ILLINOIS POWER COMPANY

September 28, 1984

Subject: Clinton Power Station Unit 1  
DRAFT Technical Specifications

Illinois Power is enclosing a revised mark-up of the Clinton Power Station "DRAFT" Technical Specifications for your review. The changes indicated in the enclosure are provided as a result of our review of plant specific design information, information contained in the Clinton Power Station Final Safety Analysis Report, requirements/commitments delineated in the Clinton Power Station Safety Evaluation Report (NUREG-0853) through Supplement No. 3, and the Technical Specifications of recent licensees.

Clinton MCPFR<sub>f</sub> (K<sub>f</sub>) Versus Core Flow  
Figure 3.2.3-1

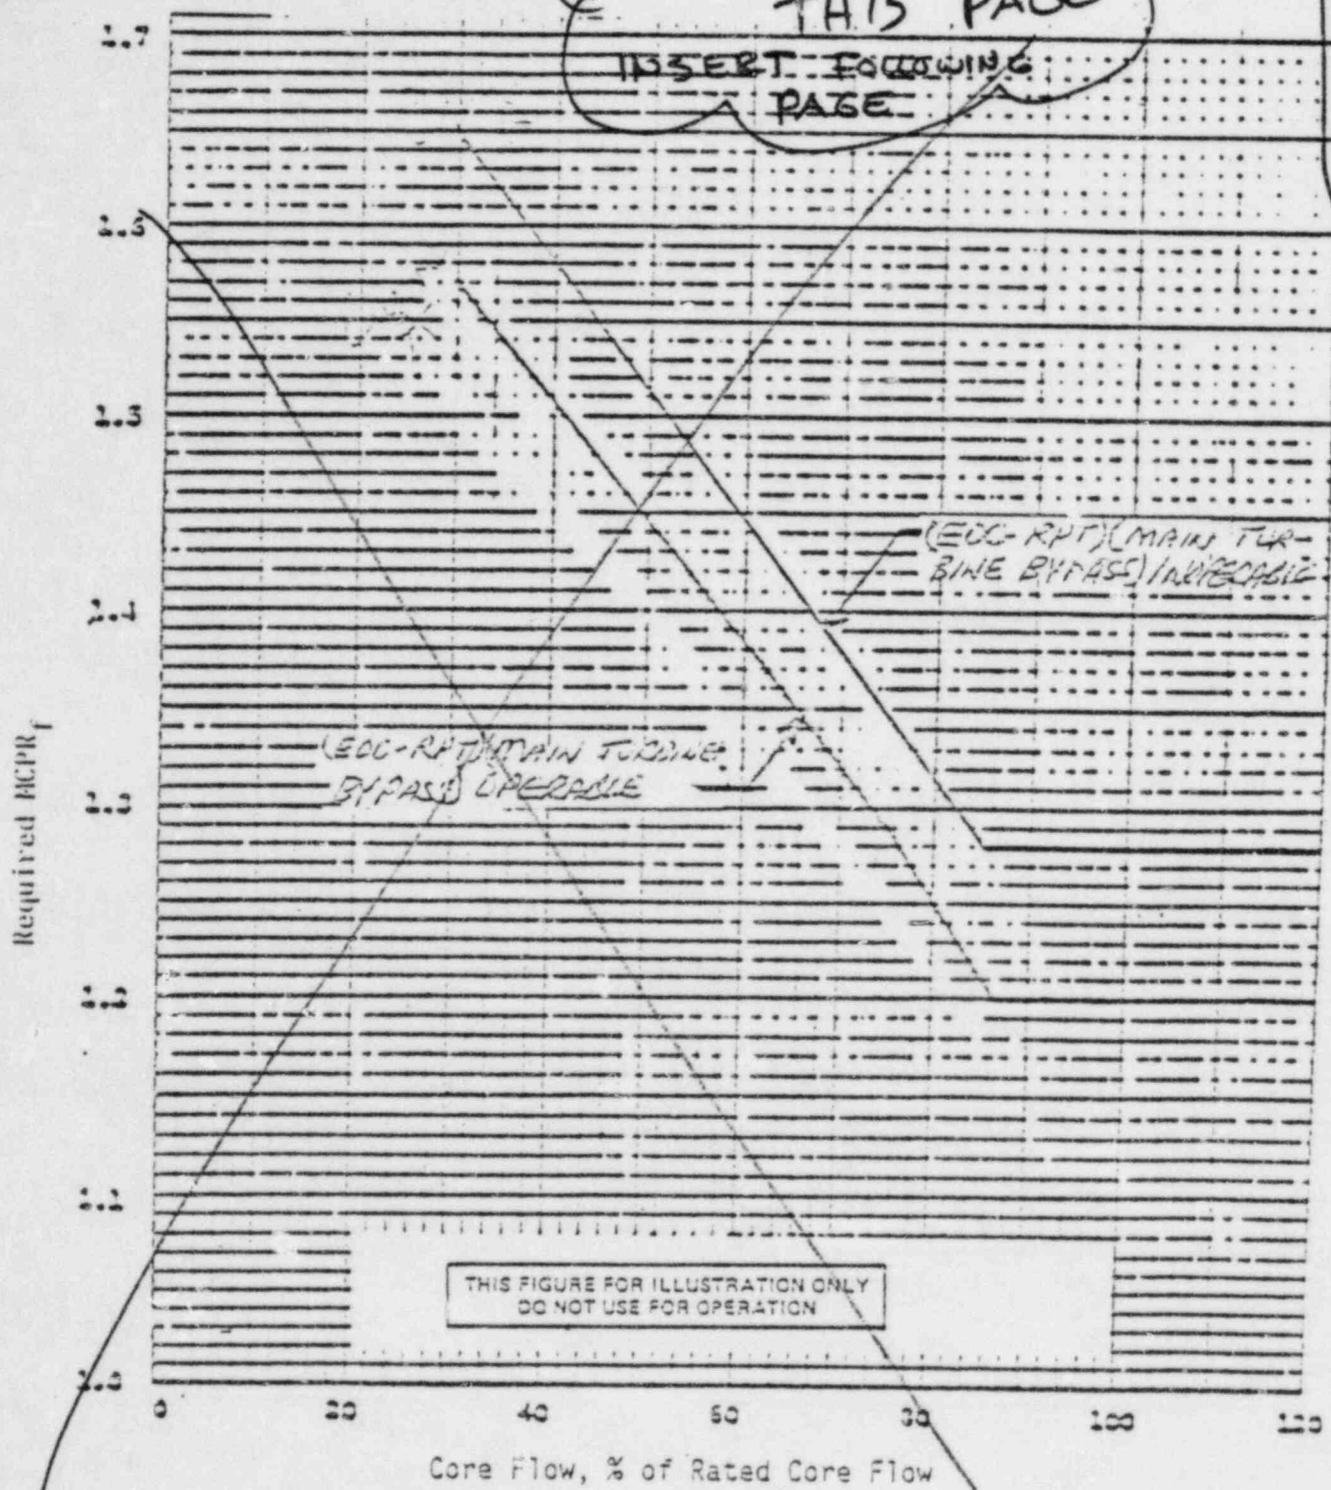
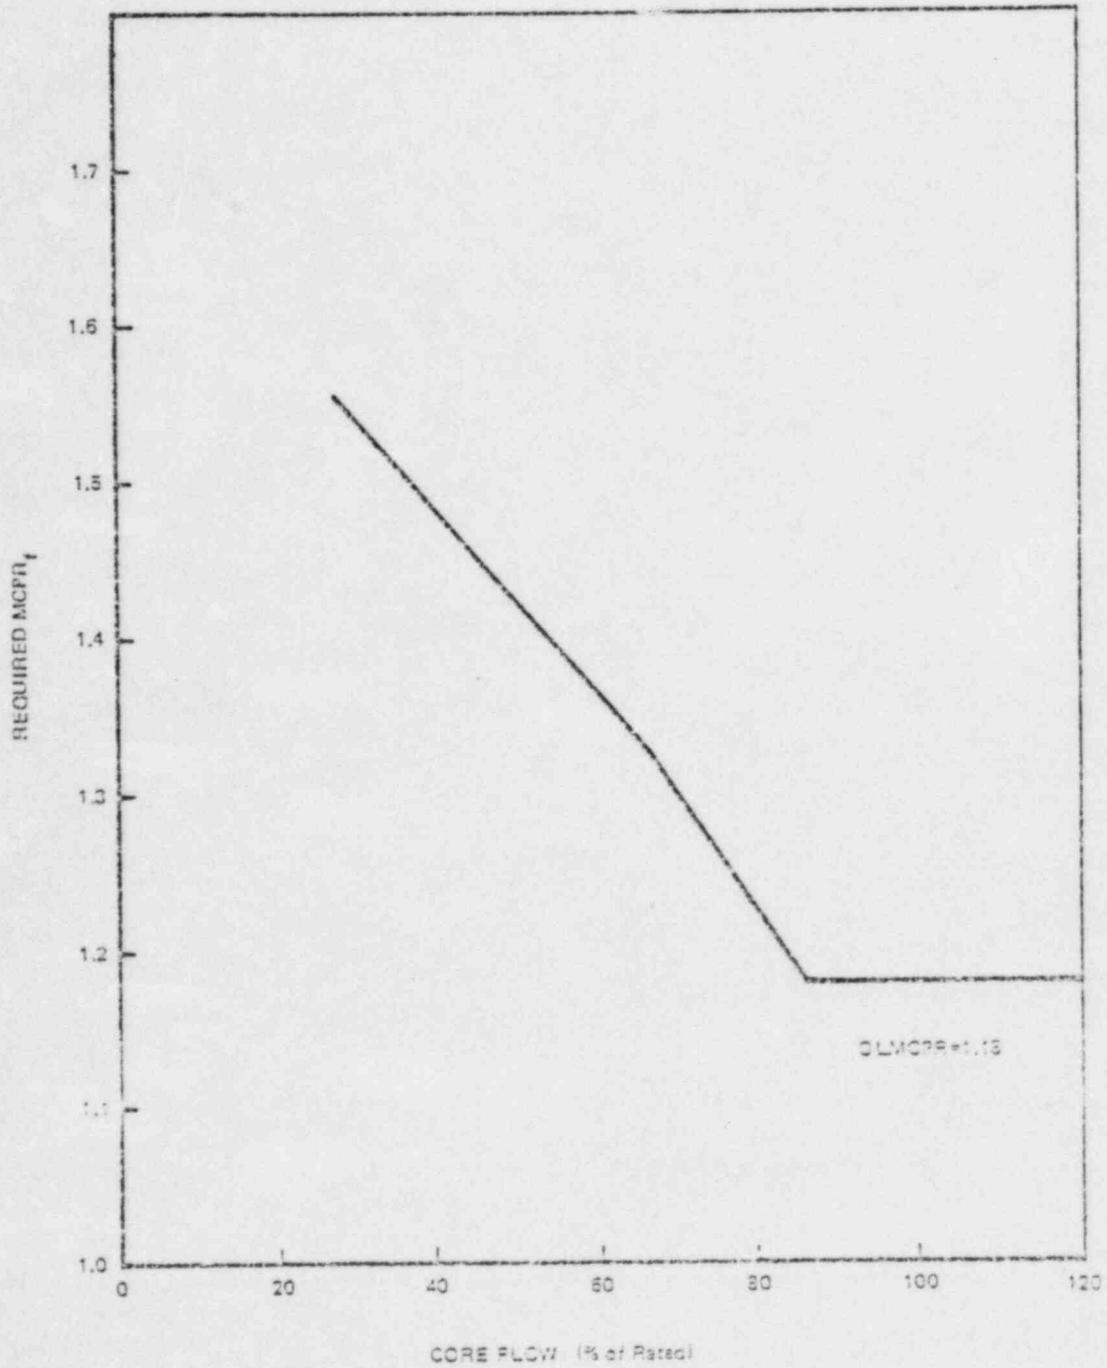
DELETE THIS PAGE  
INSERT FOLLOWING PAGE

Clinton MCPR<sub>p</sub> (K<sub>G</sub>) Versus Power  
Figure 3.2.3-2

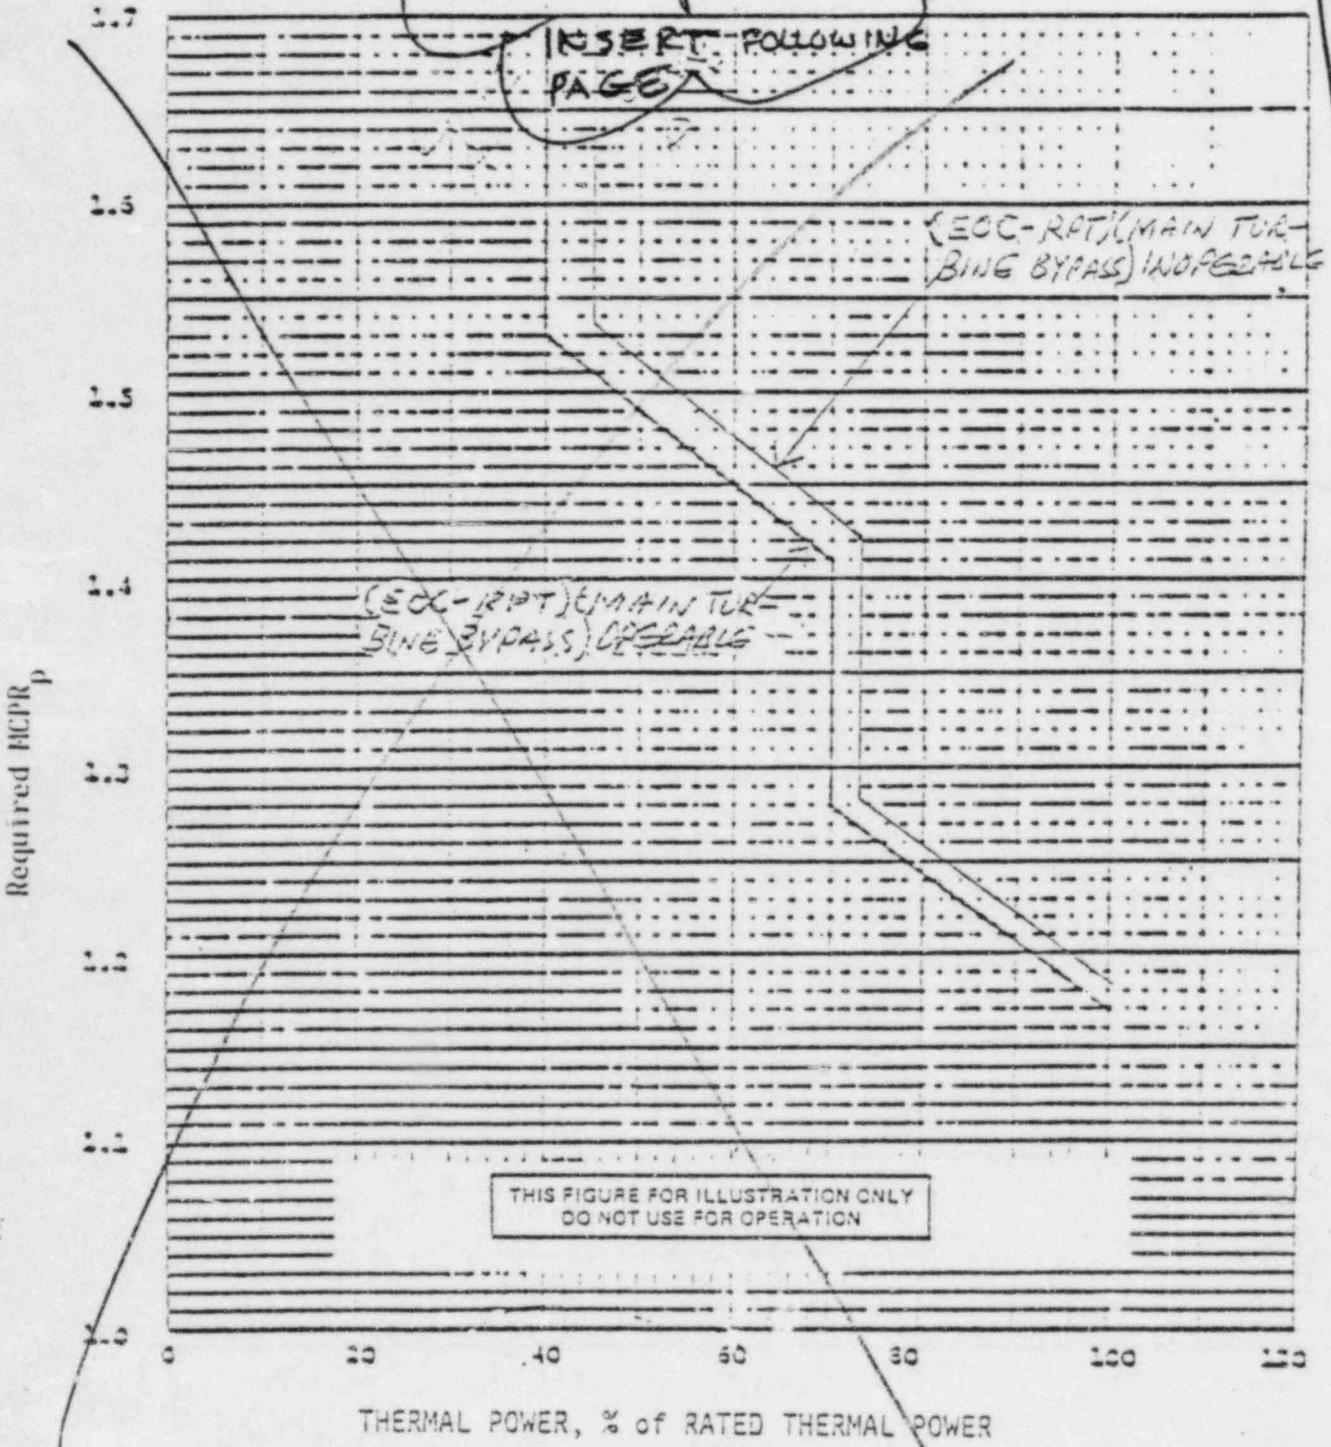
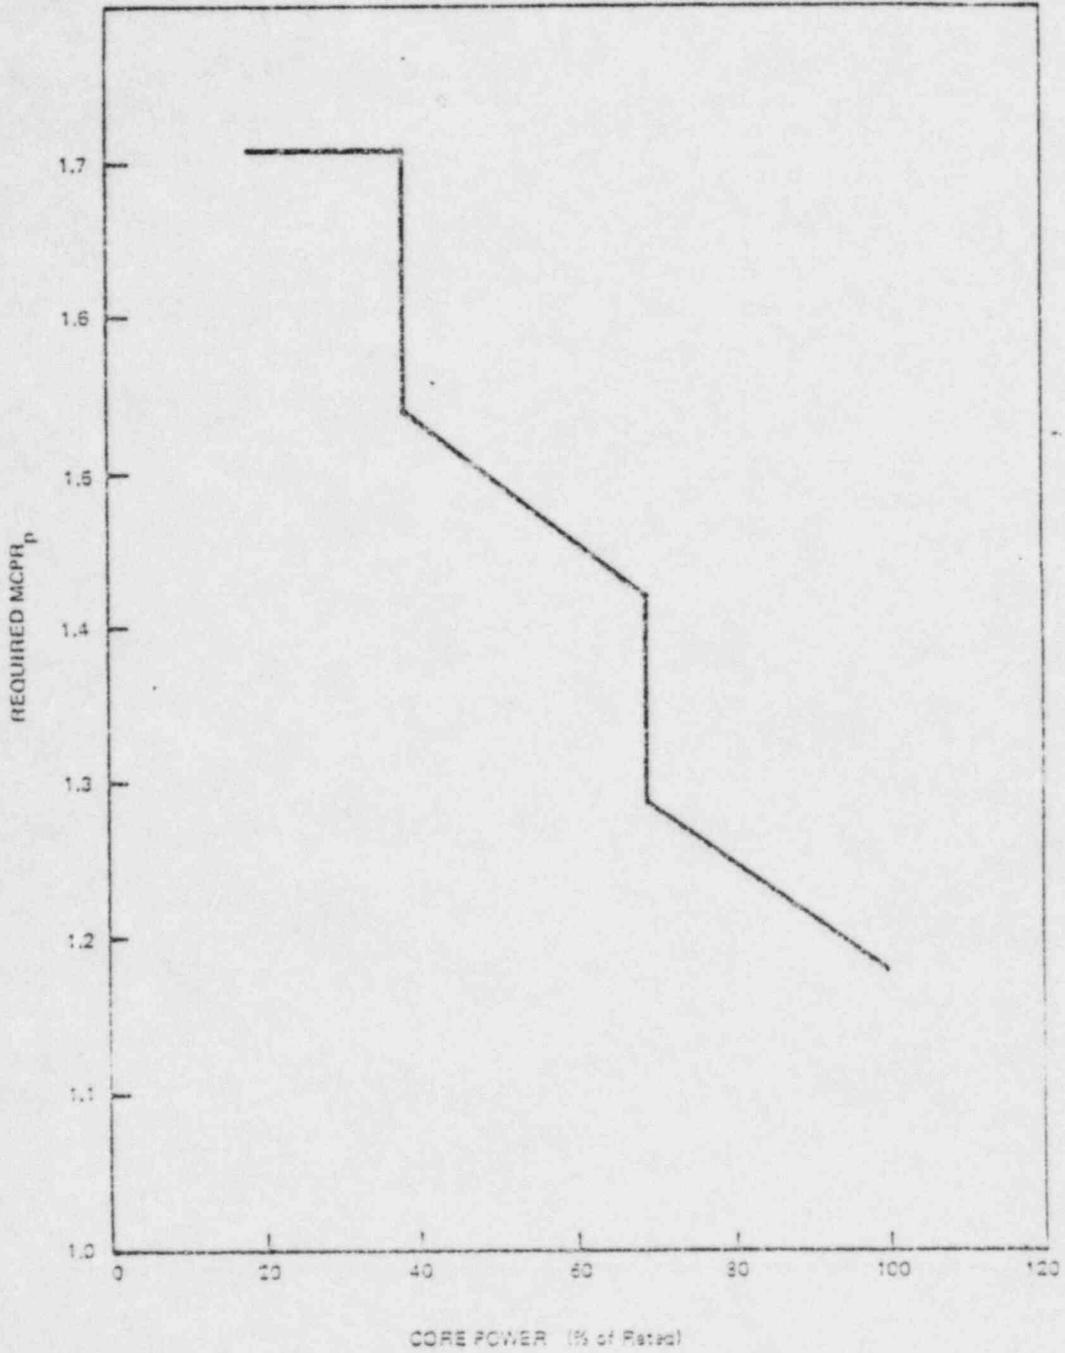
DELETE THIS PAGE

INSERT FOLLOWING PAGE

Figure 3.2.3-1

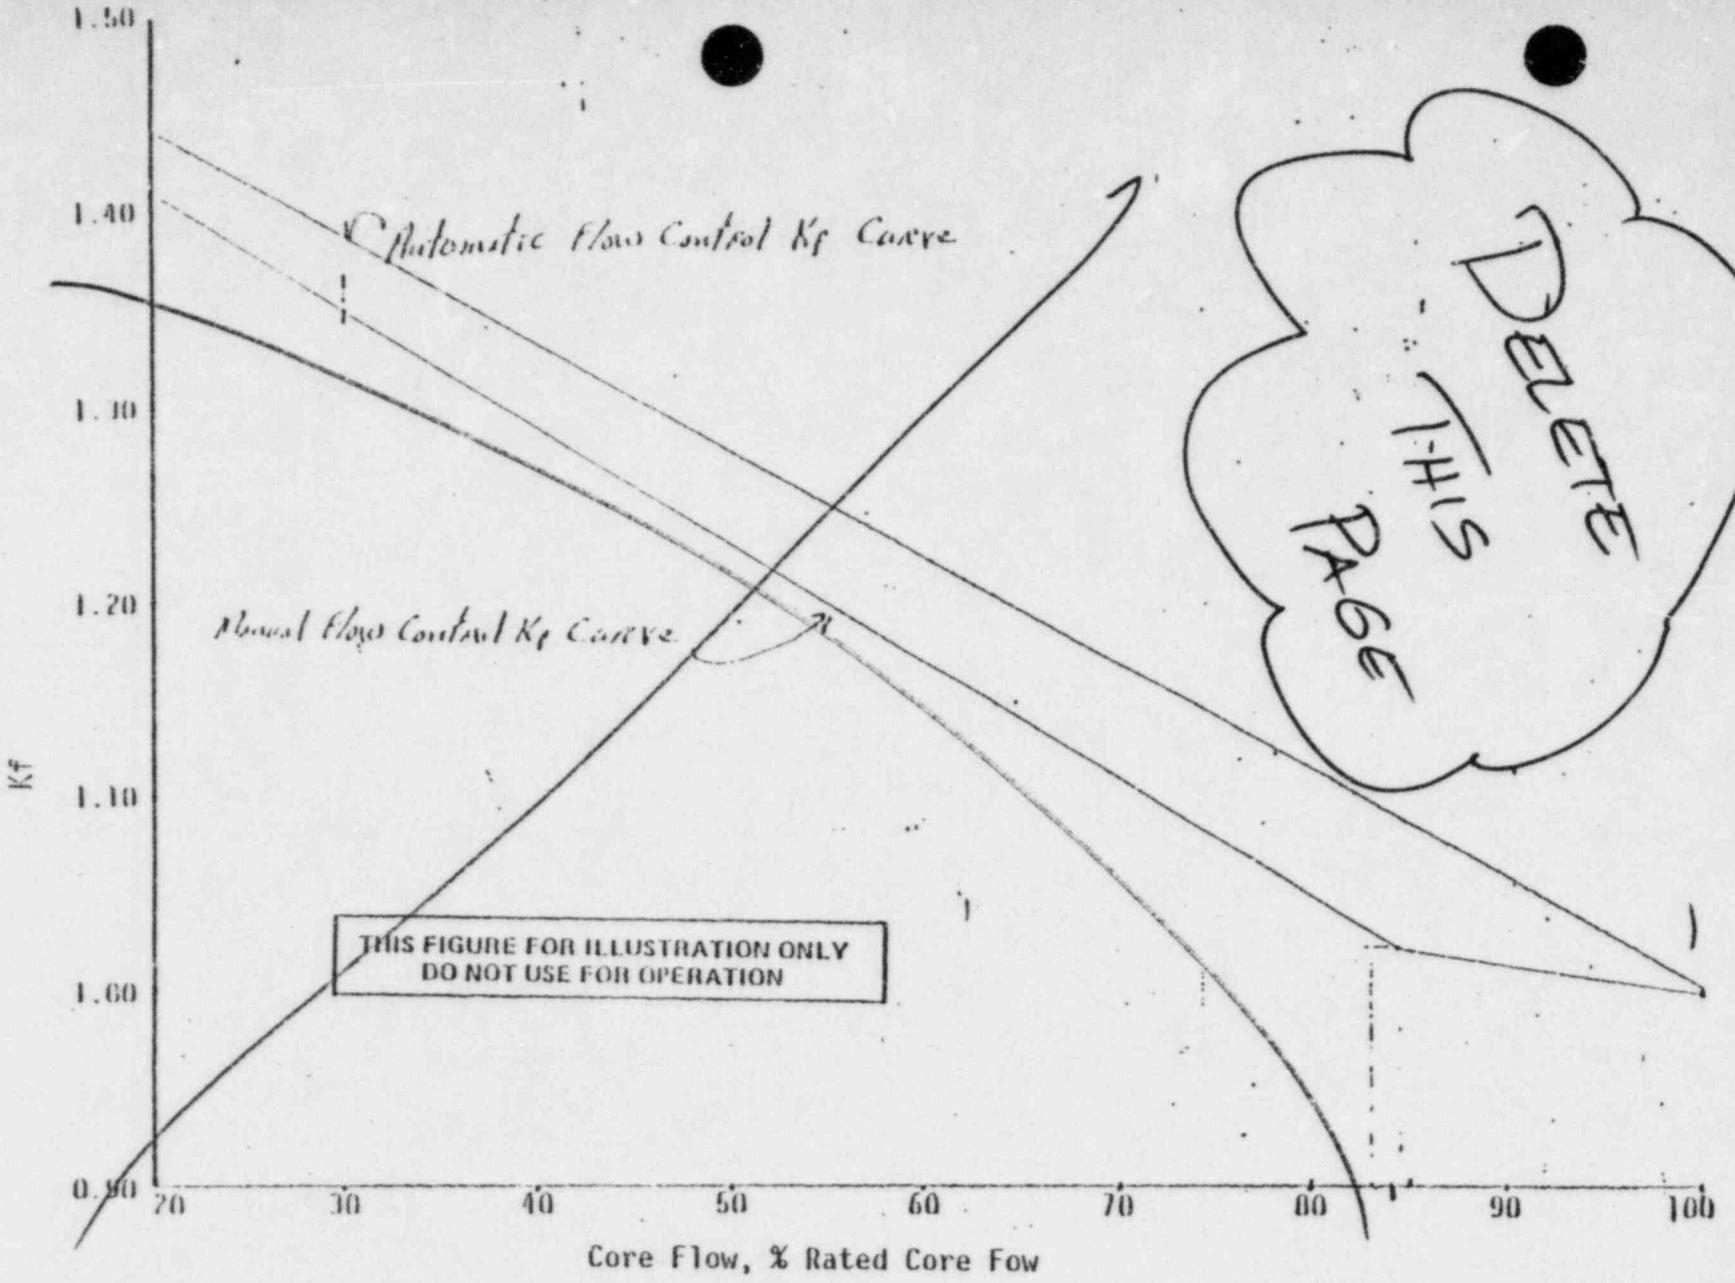
DELETE  
THIS  
PAGE

MINIMUM (REACTOR PRESSURE VESSEL METAL) TEMPERATURE REACTOR VESSEL PRESSURE  
Figure 3.4.6.1-1

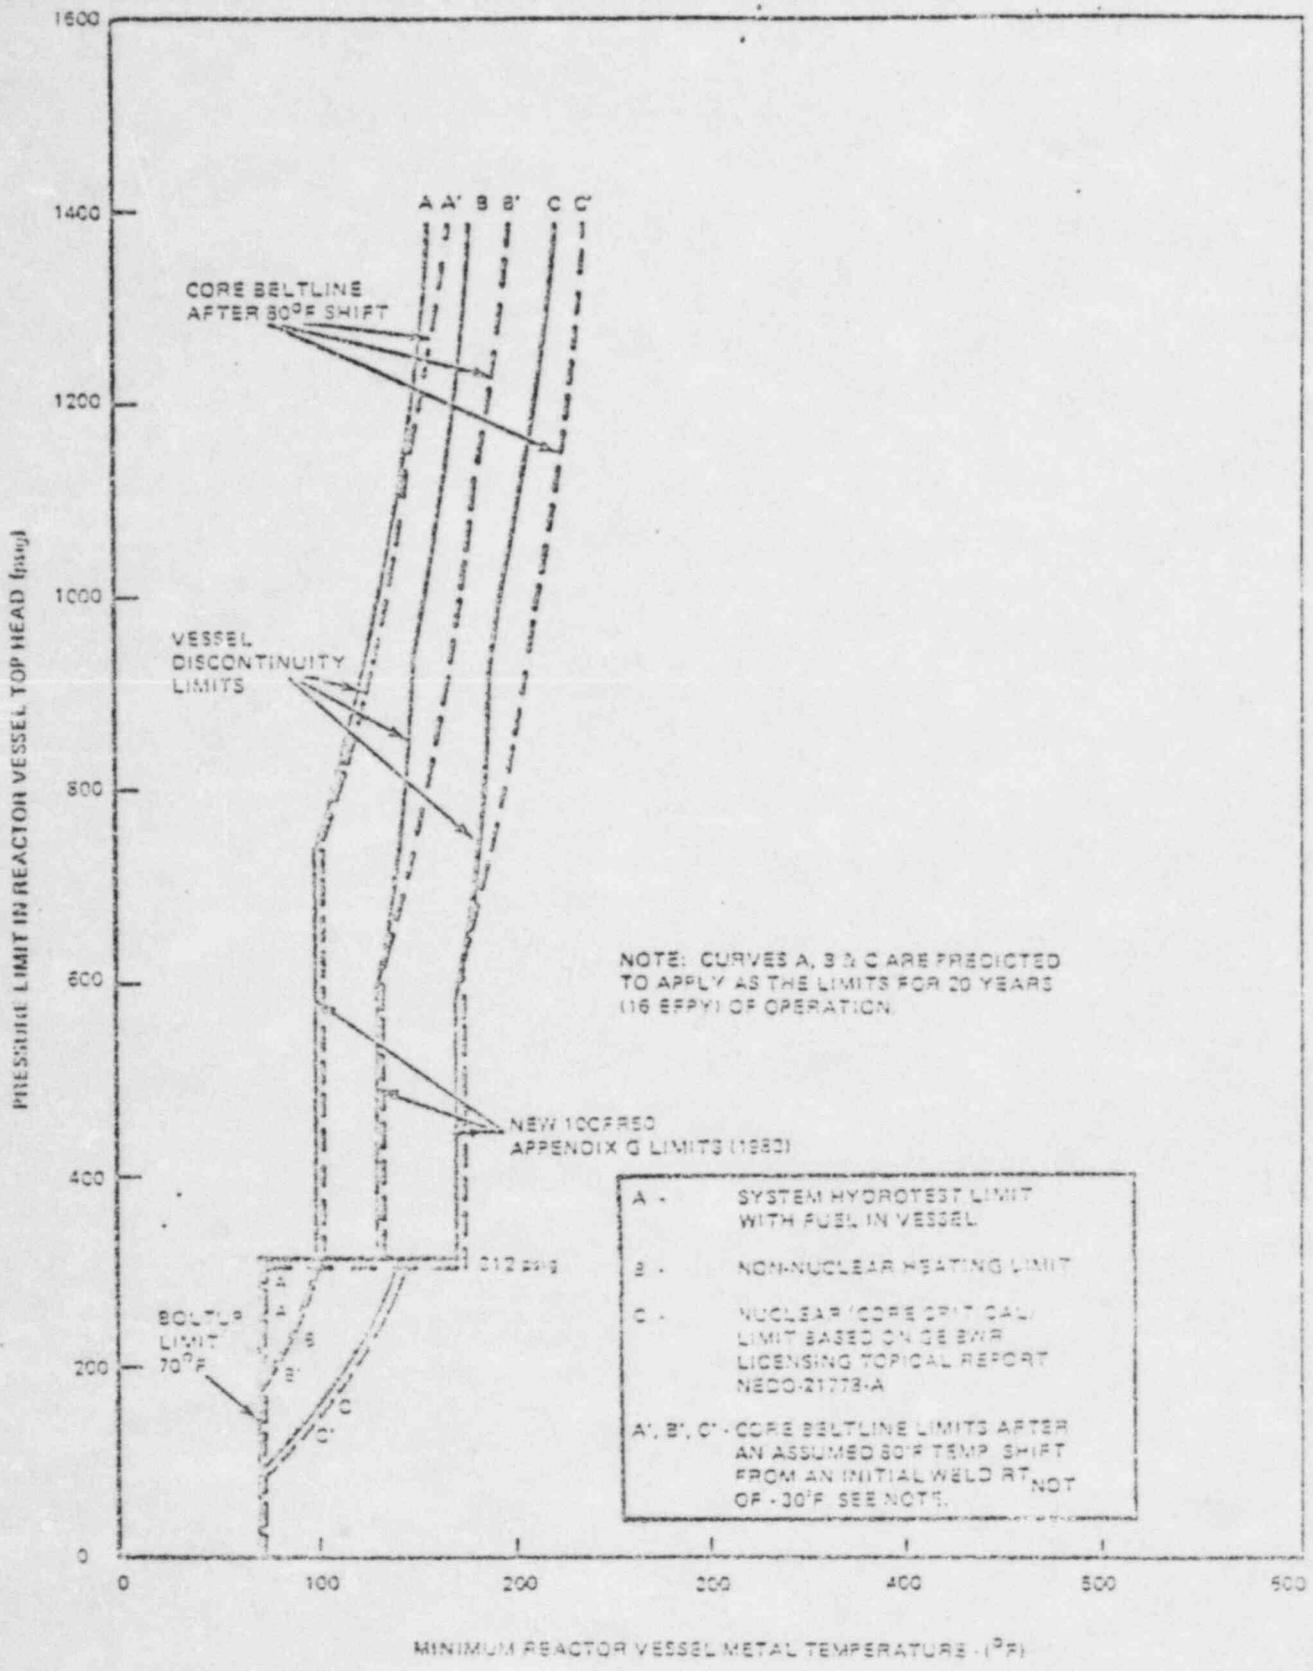
3.4.6.1 The reactor ~~coolant system temperature and pressure~~ <sup>vessel pressure and metal temperature</sup> shall be limited in accordance with the limit lines shown on Figure 3.4.6.1-1 (1) curves A and A' for hydrostatic or leak testing; (2) curves B and B' for heatup by non-nuclear means, cooldown following a nuclear shutdown and low power PHYSICS TESTS; and (3) curves C and C' for operations with a critical core other than low power in PHYSICS TESTS, with: | CPS

DELETE AND INSERT FOLLOWING PAGE
